72+ COLLINS CONDOMINIUM

7134 Collins Avenue
Miami Beach, Florida 33141

DESIGN REVIEW BOARD PRESENTATION

LEVELS 5, 6 & 7 - BUILDING PLAN

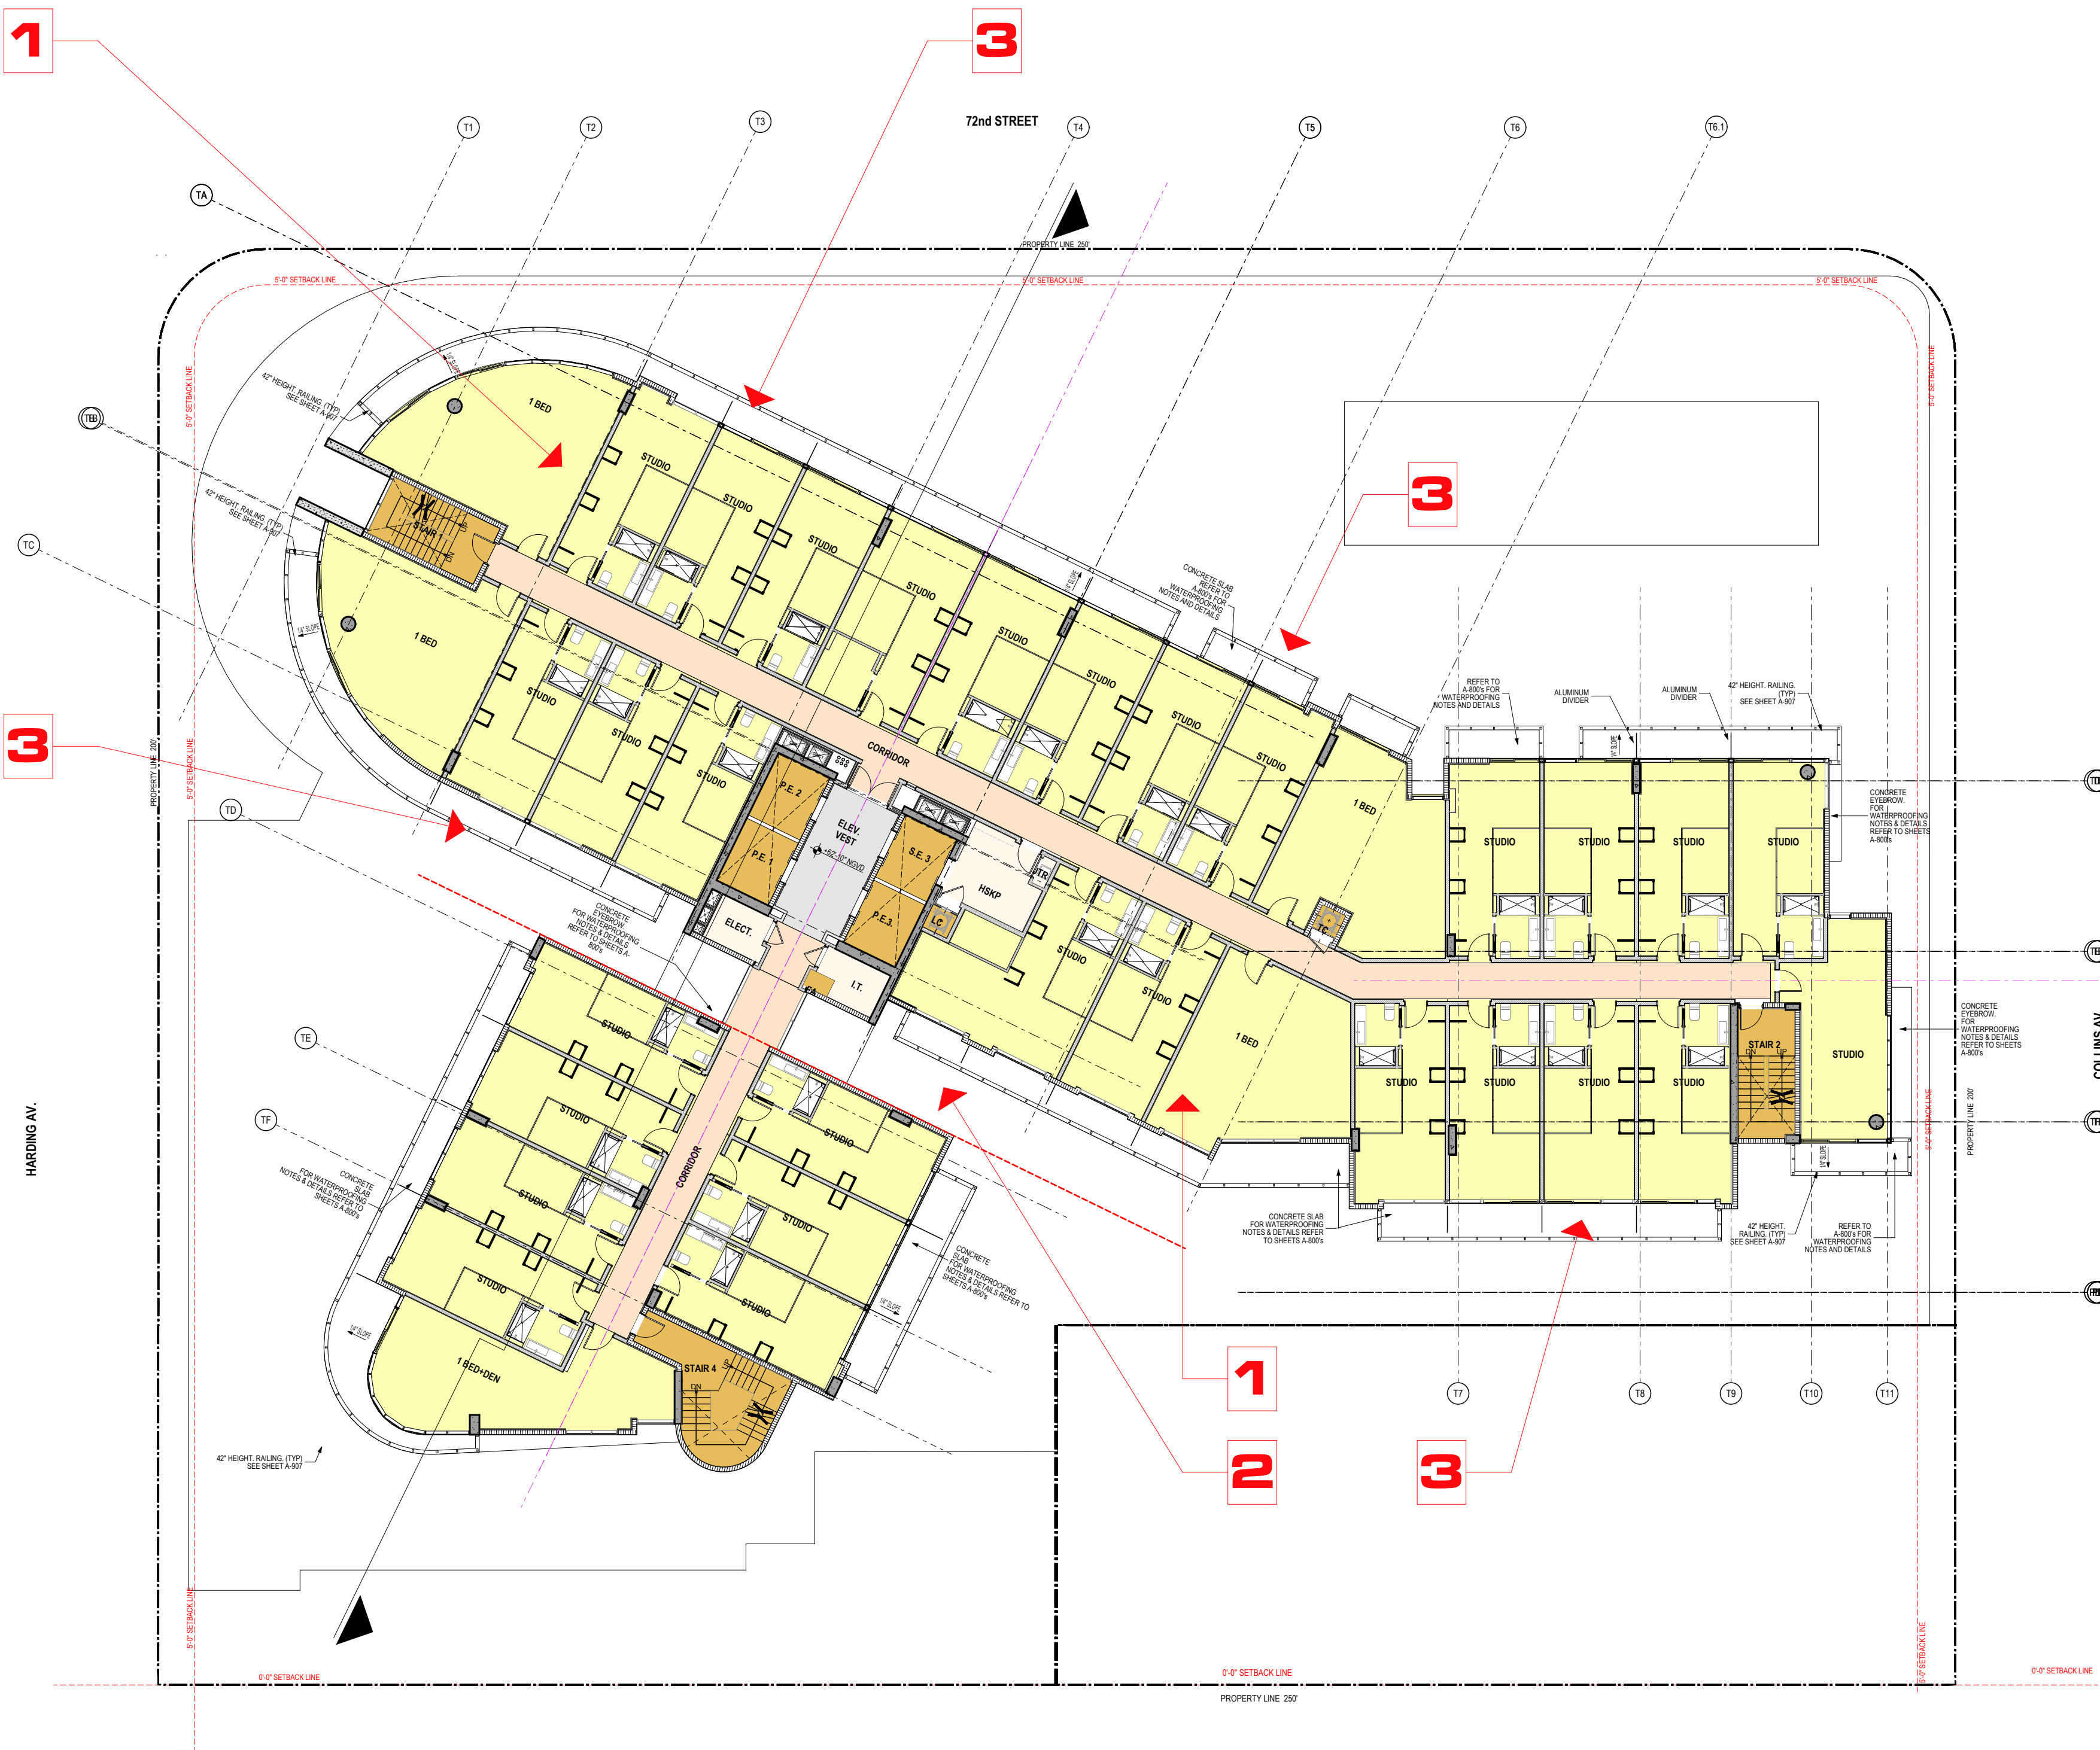
- INTERIOR ORGANIZATION TO ACCOMMODATE CO-LIVING UNITS
- DISTANCE BETWEEN MAIN TOWER AND ANNEX BUILDING INCREASED TO IMPROVE BREEZEWAY LIGHT, AND VIEW OF CENTRAL UNITS
- REPLACING OF PREVIOUSLY APPROVED EYEBROWS BY BALCONIES AT NEW CO-LIVING UNITS

LEVEL 8 - BUILDING PLAN

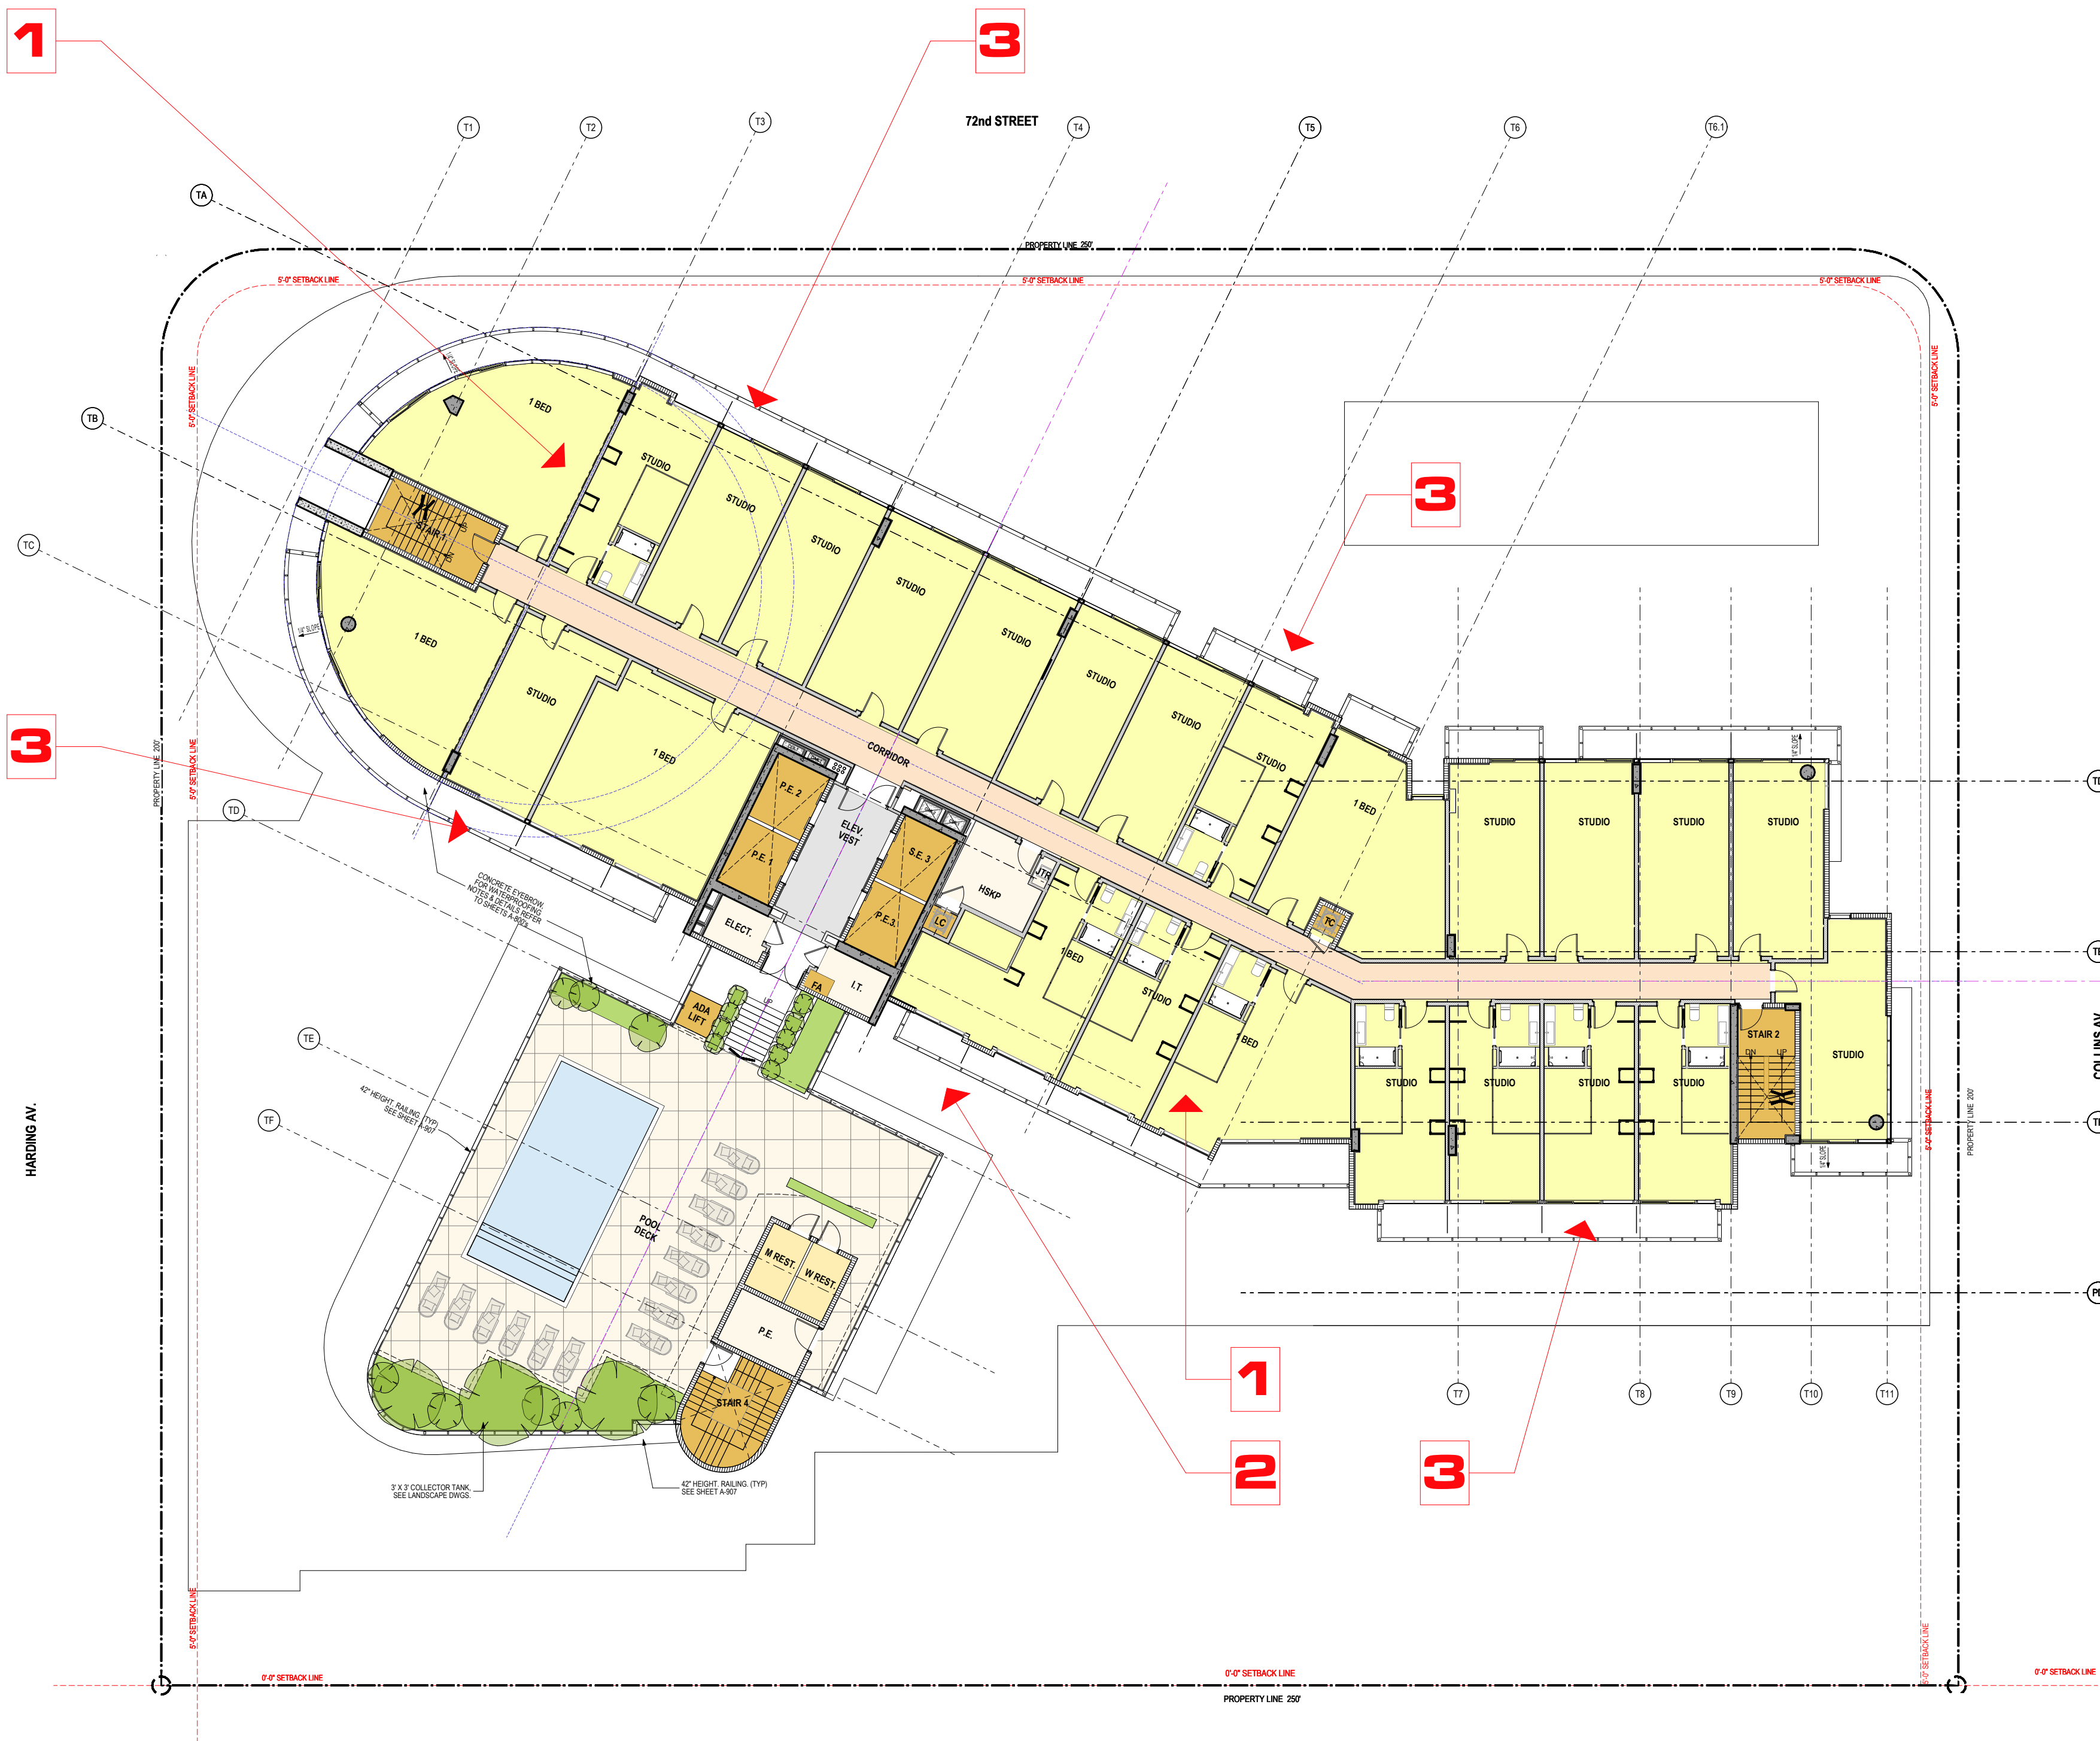
- INTERIOR ORGANIZATION TO ACCOMMODATE CO-LIVING UNITS AND NEW REGULAR UNITS
- DISTANCE BETWEEN MAIN TOWER AND ANNEX BUILDING INCREASED TO IMPROVE BREEZEWAY LIGHT, AND VIEW OF CENTRAL UNITS
- REPLACING OF PREVIOUSLY APPROVED EYEBROWS BY BALCONIES AT NEW CO-LIVING UNITS
